WORKSHOP AGENDA

Planning Commission

April 15, 2025 @ 5:30 PM

For the April 29, 2025 Regular Meeting @ 6:00 PM

C03.02

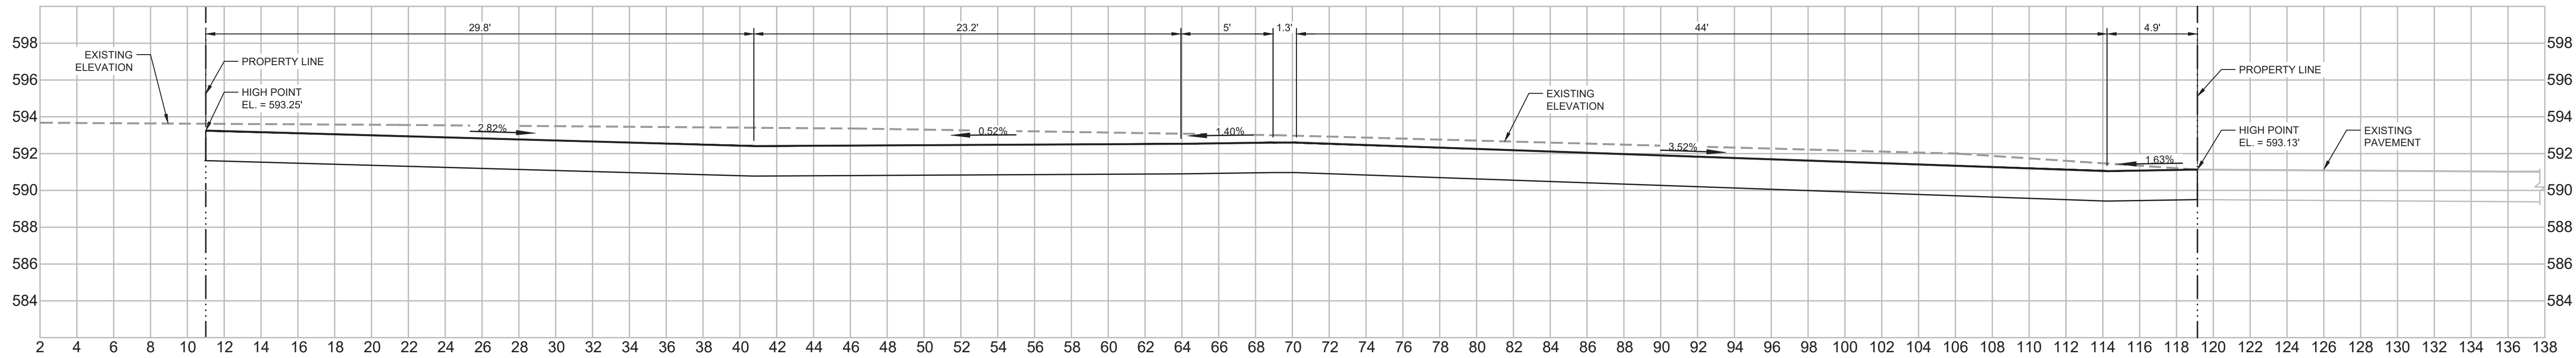
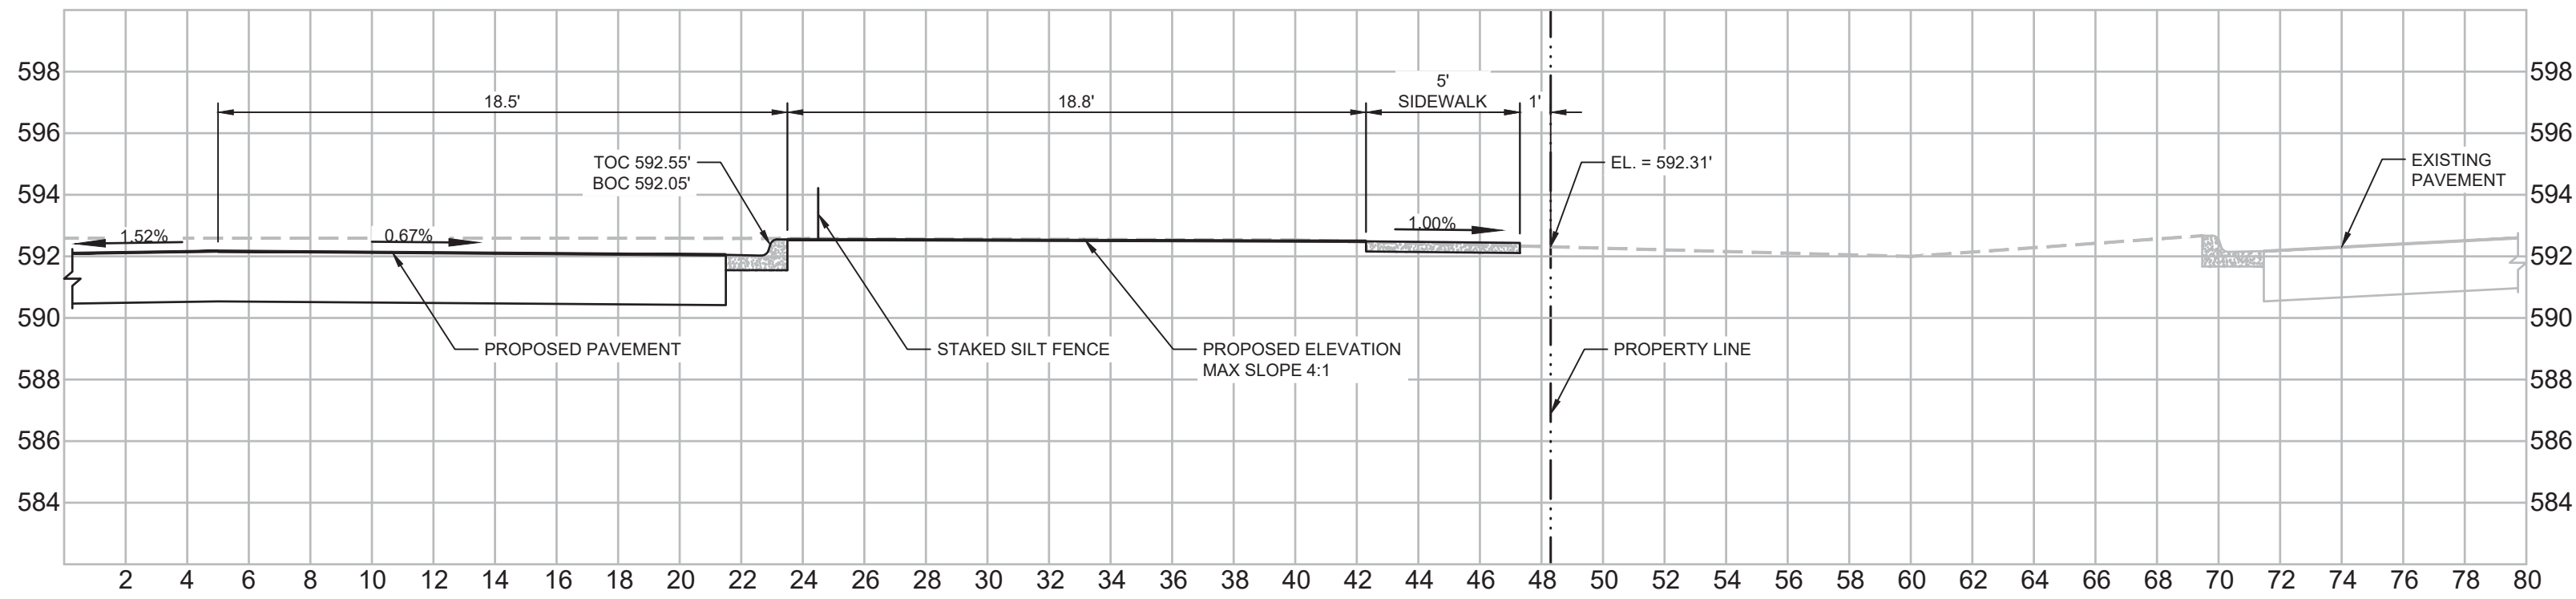
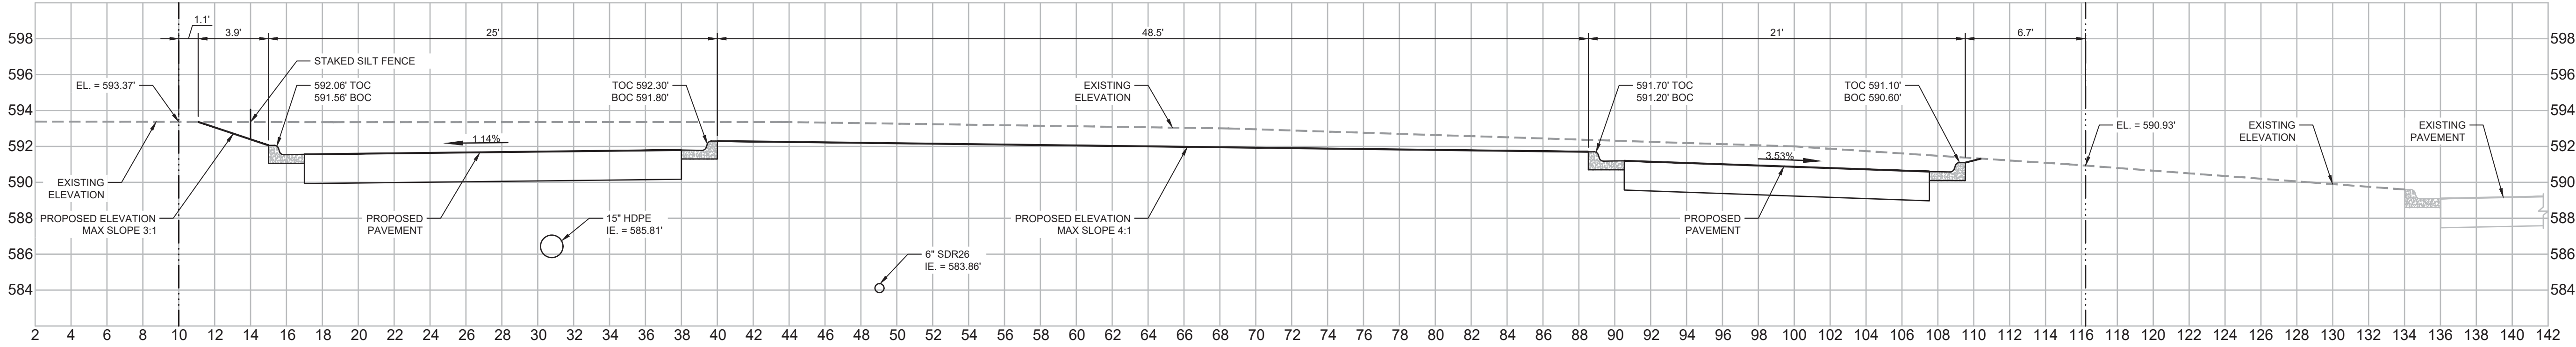
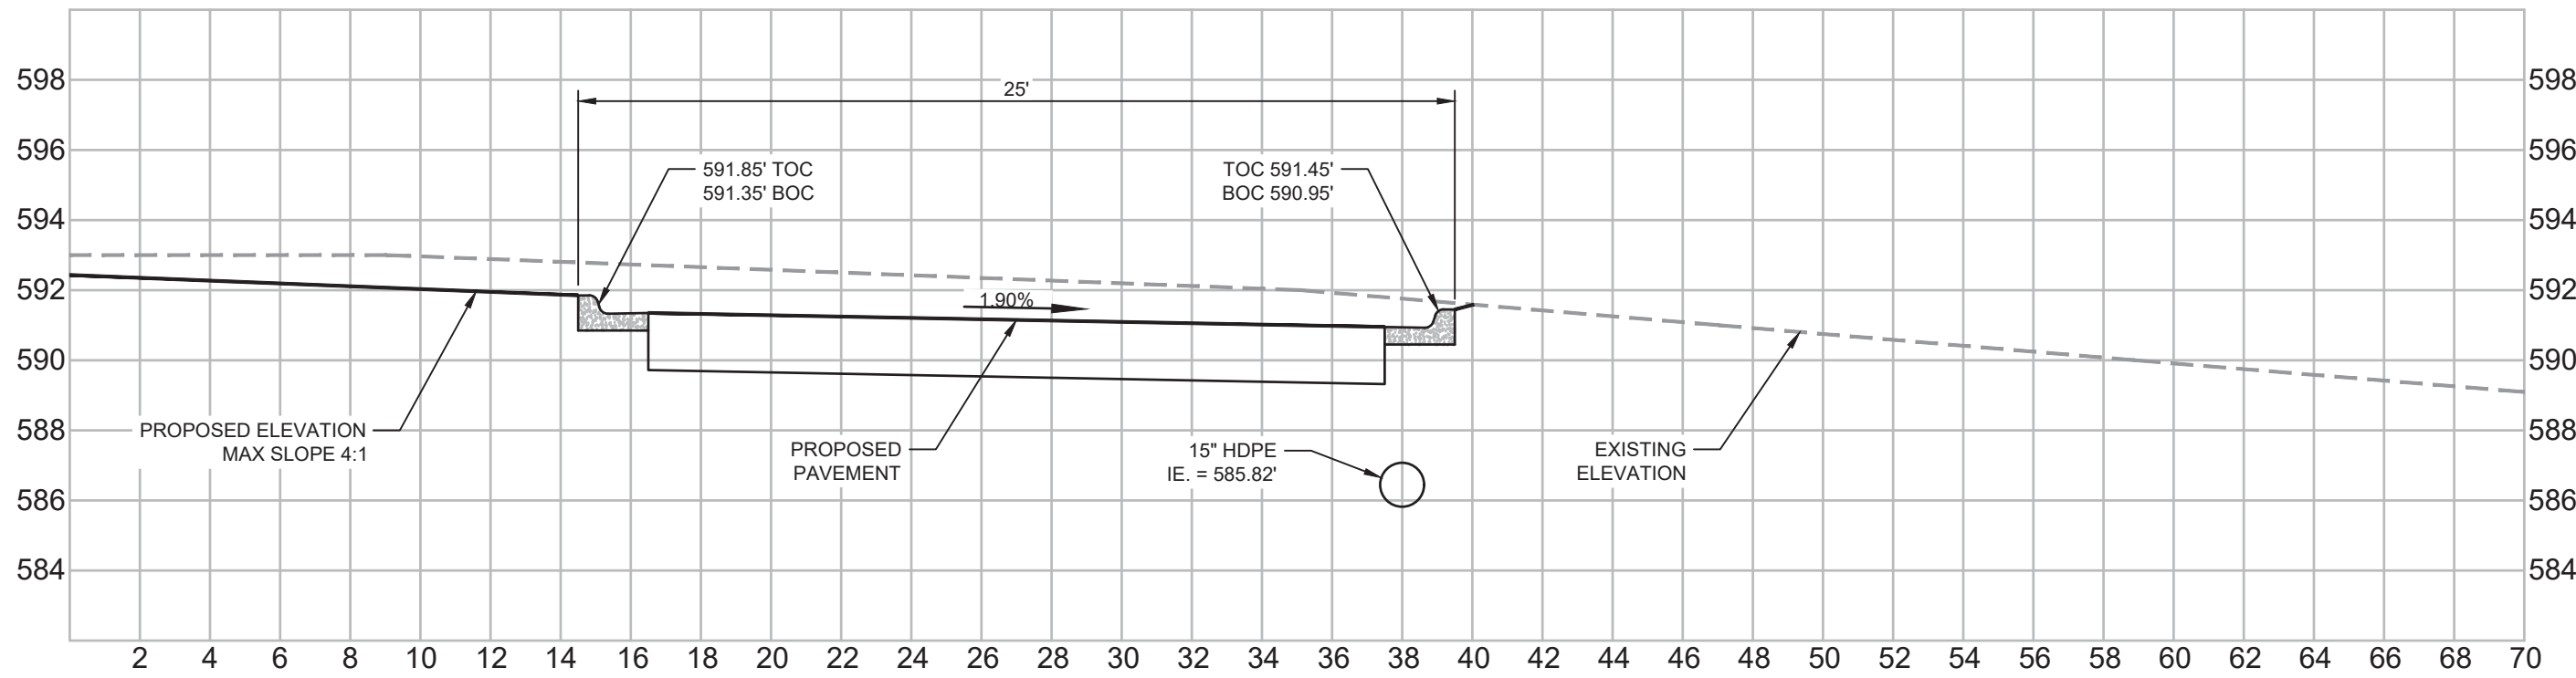
1. (C03.02 and C05.06) Given the comparative inverts between the existing 21" RCP and the new incoming pipe, the city would prefer a complete manhole rather than a doghouse for ST-9. If you choose to proceed with the doghouse, please add a detail which shows how you are going to cut the existing pipe and take it down to the new inlet invert and maintain an enclosed bottom.

2. (C03.02) Pipe ST-8 should be run perpendicular from ST-7 to the existing 21" RCP at ST-9. If this is not possible, let us know why.
3. (C02.01) Show monument sign location if one is proposed.
